Date: 24/10/2023  
PINS Ref: APP/X5210/W/23/3323840  
Our Ref: 2022/4293/P  
Contact: Ewan Campbell  
Direct Line: +44 20 7974 5458  
Ewan.campbell@camden.gov.uk

**Appeal site: 139-147 Camden Road, Camden, London , NW1 9HJ**  
**Appeal by: Mr Vijay Pindoria**

**Proposal: Erection of 4 storey block of flats with ground floor bin and bicycle stores and front paving and planting**

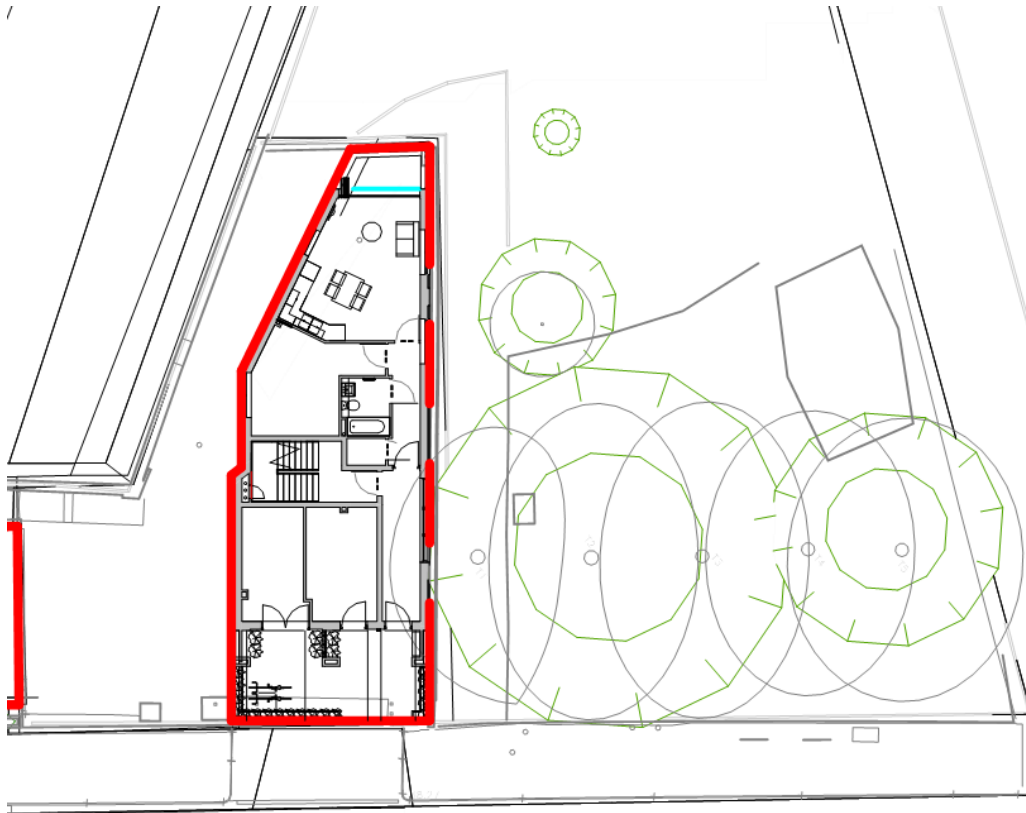
3.9 In relation to paragraph 2.14-2.18 and 2.23-2.24 where issues of the developments response to the area and the design itself, the design proposal shows a lack of respect to the locality with a confused palette of materials, and a façade expression that is out of keeping with existing character. The decorative ‘feature brickwork’ details included may provide relief from the single planes of brickwork, but their add-hoc locations are unsympathetic and contribute to the confused architectural language. The proposal for two different brick types creates a strong contrast, which acts to exaggerate the overall bulk.

3.10 The ground floor facing on to Camden Road does not contribute positively to the street frontage, as outlined in Local Plan Policy D1f. The detailed design of the entrances leave a significant proportion of inactive frontage through blank doors. This fails to address Local Plan Policy D1i regarding security, alongside providing only stepped access which presents a lack of ingress that is inclusive and accessible for all as required by Local Plan Policy D1g. The upper façade facing Camden Road exhibits a gridded character, described as columns, but more accurately considered as pilasters. The materials are a buff brick with infill of grey brick detailing surrounding grey framed windows. The windows are full height, with their size and proportion failing to complement the local character. The upper 3rd floor is set back by approximately 1m and clad in grey brick. This character is out of keeping with the context and demonstrates a lack of respect for the local character, thereby a failure to comply with Local Plan Policy D1e.

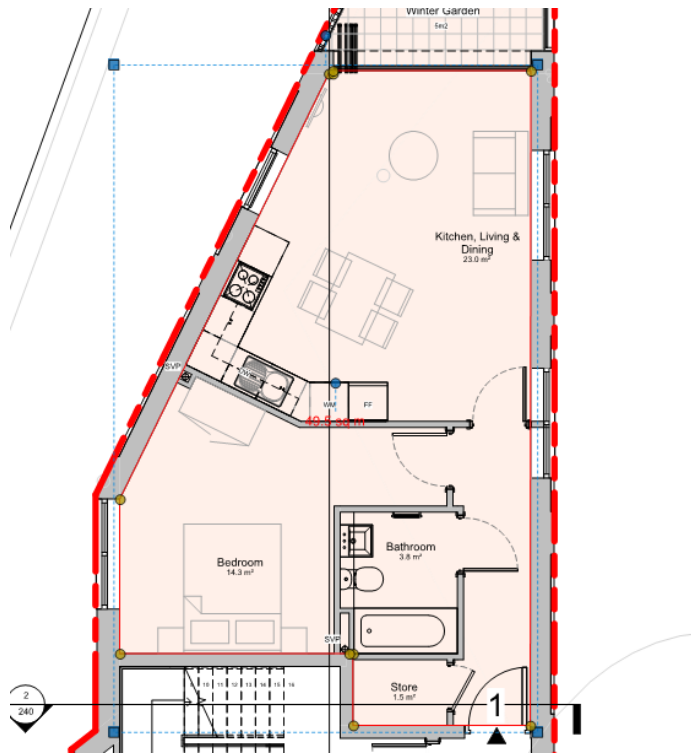
3.16 As part of the officer report it was explained that the 'terraces' or winter gardens cannot count towards the internal GIA and should not be offset against the units meeting NSS. There does not appear to be any evidence put forward that this should change and therefore it is still the Council's position.

Ground floor unit 1

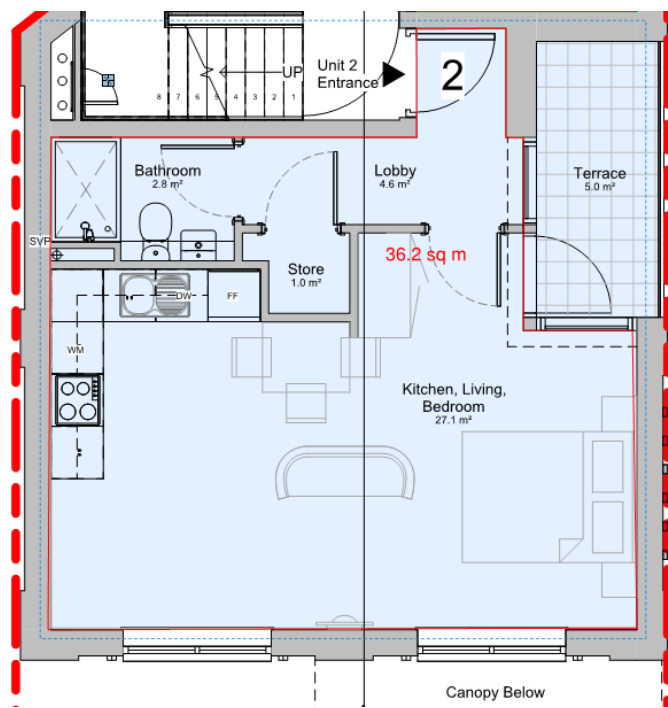
3.17 Below are screenshots from the submitted plans demonstrating that the floor areas are incorrect and more importantly fail the NSS standards for their respective unit sizes:

*First floor unit 3*

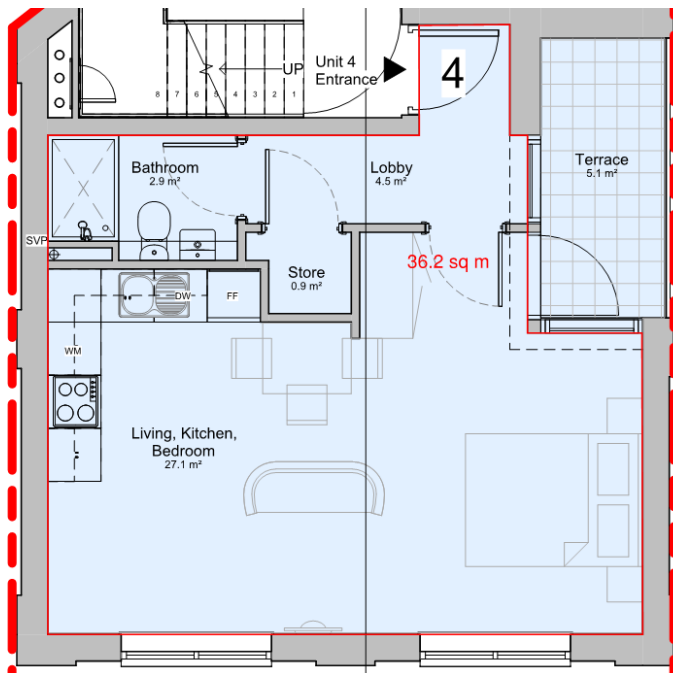
**Unit 3 - 1 Bed 2 Person Flat**  
 Floor Area - 54.10m<sup>2</sup>  
 Minimum NDSS - 50m<sup>2</sup>
